DRAINAGE AND TRANSPORTATION INFORMATION SHEET (REV 1/2016)

Project Title: Valle de Atrisco **Building Permit #:** BP-2017-30394 **Hydrology File #:** PO9 1002D
DRB#: _____ **EPC#:** 10044281/16-EPC-40037 **Work Order#:** _____
Legal Description: Lots RR-3 & RR-3A & RR-3B, located on Dennis Chavez Blvd. SW Albuquerque, New Mexico
City Address: 10001 Ceja Vista Road Albuquerque, New Mexico

Re: Valle de Atrisco
10001 Ceja Vista Rd.
Traffic Circulation Layout
Architect's Stamp 10-02-17 (P09-D002D)

TRAFFIC
CIRCULATION
LAYOUT

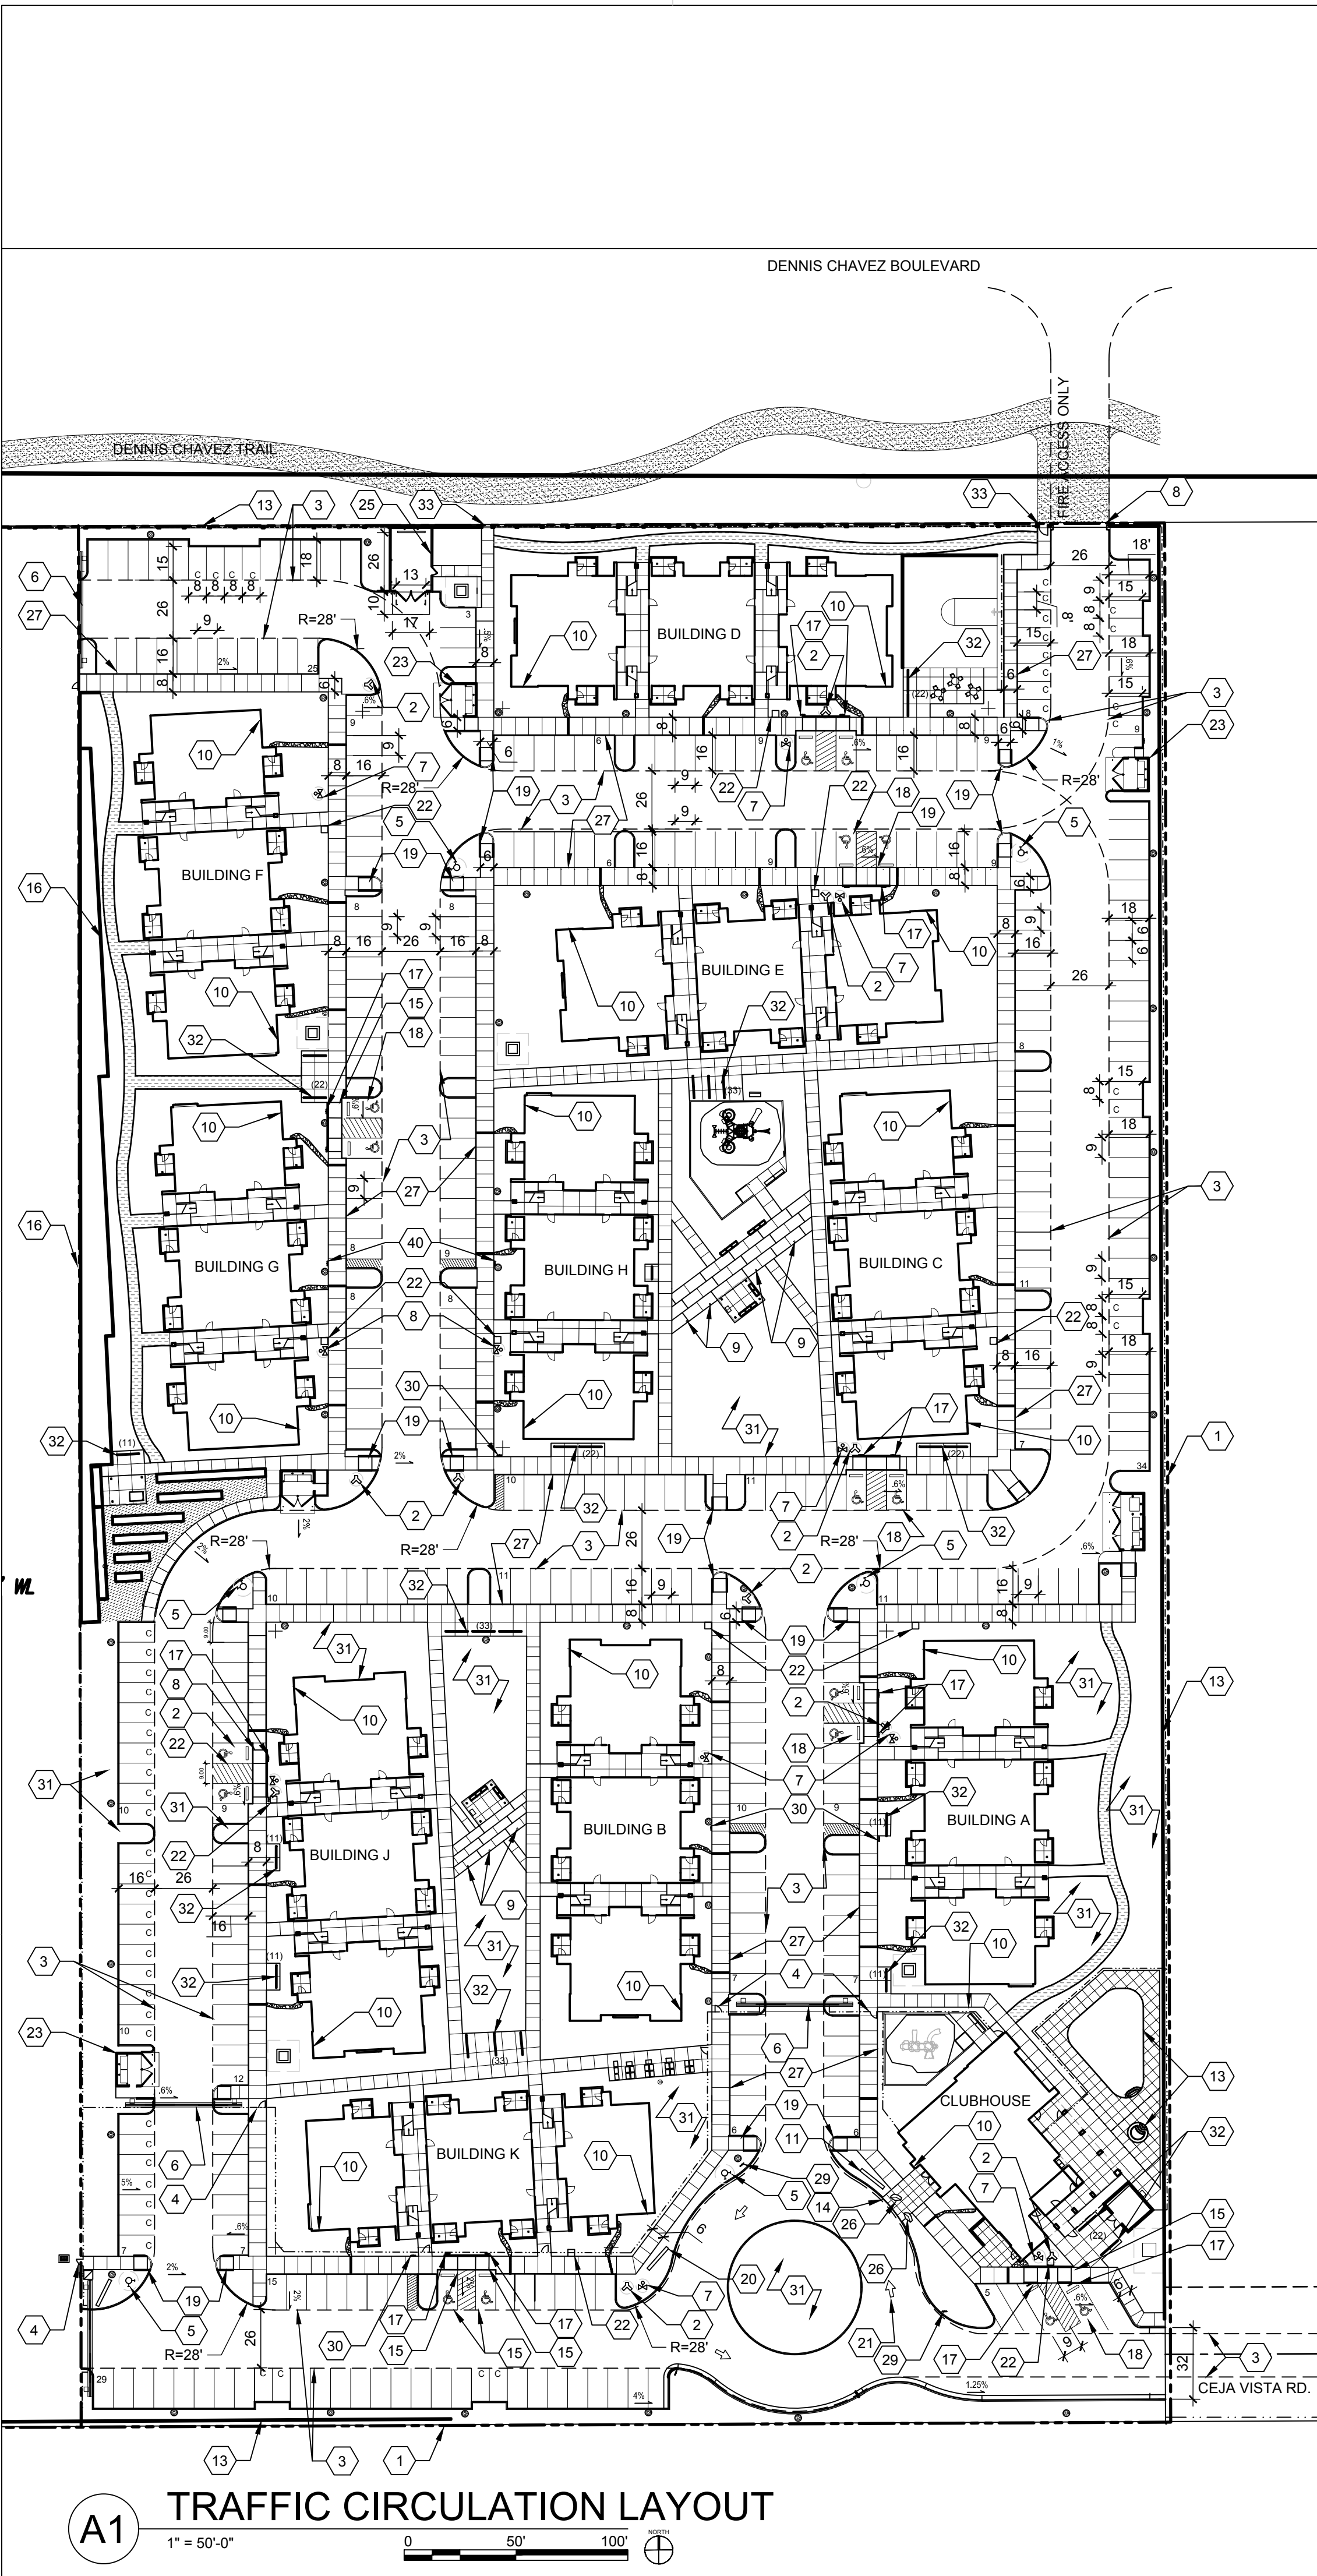
1. Dennis Chavez is a limited access road way. The emergency access must be approved off NM 500. Contact MRCOG to get approval from the Roadway Access Committee (RAC) and the Metropolitan Transportation Board (MTB).

2. Please coordinate with NMDOT District 3 Traffic for driveway permit on Dennis Chavez NM 500. Please include us in all correspondences. Contact Nancy Perea @ Nancy.Perea@state.nm.us and Margaret Haynes @ Margaret.Haynes@state.nm.us.

3. Identify all existing access easements and right of way width, and street widths on Ceja Vista Rd and Dennis Chavez Blvd. Roadway shall be built with DRC approved City Work Order.

4. A 5 ft. keyway is required for dead-end parking aisles. The parking space next to the southwest gate should be removed. The spot is too close to the gate for vehicles to maneuver.

5. All sidewalks and trails along streets should be placed at the property line.
6. Please include a copy of your shared/cross access agreement with the adjacent property owner.

7. Please add a note on the plan stating "All improvements located in the Right of Way must be included on the work order."
8. Work within the public right of way requires a work order with DRC approved plans.
